Syracuse City Planning Commission Meeting April 2, 2019

4. Public Hearing – Request from Utah Land Surveying for a Subdivision Amendment called Cherry Village Subdivision No 1 Amended 1, approx. 0.49 acres located 2262 W 1825 S

7. Final Plat – Legend Pointe Subdivision Phase 1, located approx. 900 S 3695 W

Final Subdivision Plan Review

MASTER UTILITY PLAN

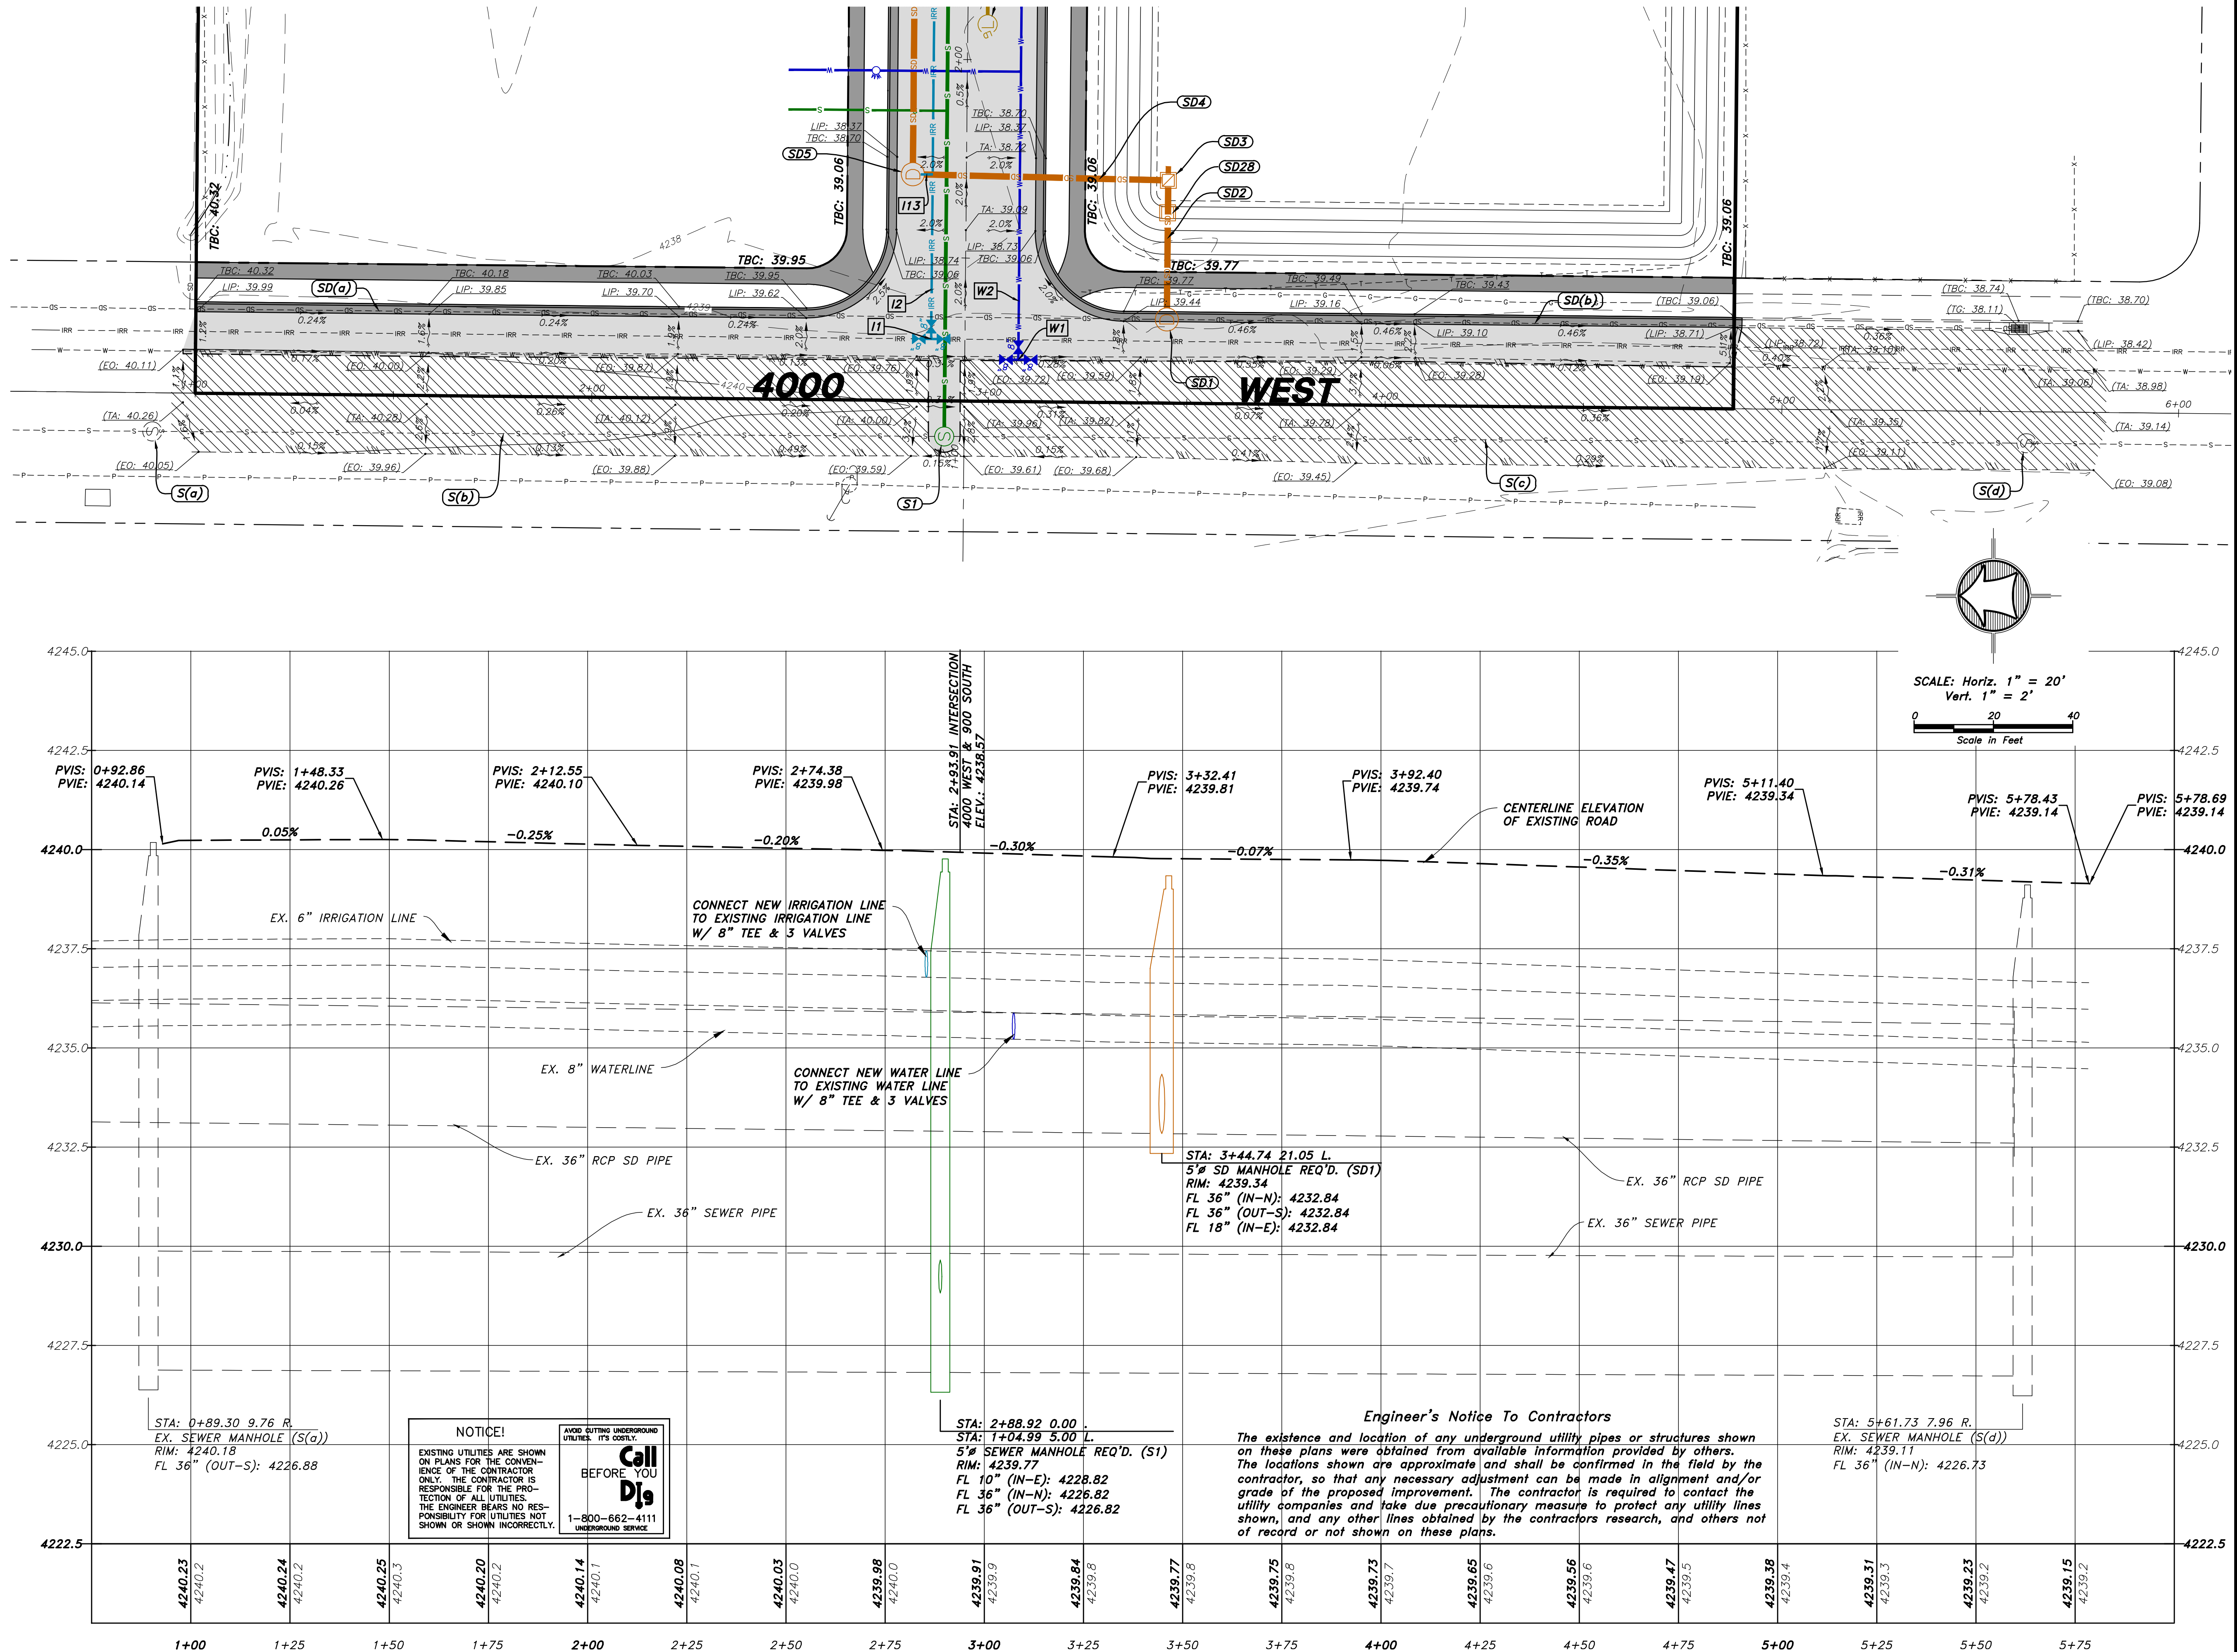
1. Submit a letter from the Davis County Health Department stating the septic tank was properly removed and abandoned prior to recording.
2. The proposed sewer connection in 4000 West is connecting to a North Davis Sewer District main. They shall be contacted for all connection approvals and standards. Their existing main in 4000 West Street is a 36" not a 15" as shown and the District restricts tie in elevations. It is recommended the District be contacted to verify connection standards.
3. The minimum cross section in 4000 West Street is 4" of asphalt on 12" of base.
4. Move the DVS-60S into 900 South Street between SD5 & SD3 north of the culinary main and south of the sewer main.
5. Maximum land drain spacing between manholes is 400 feet.
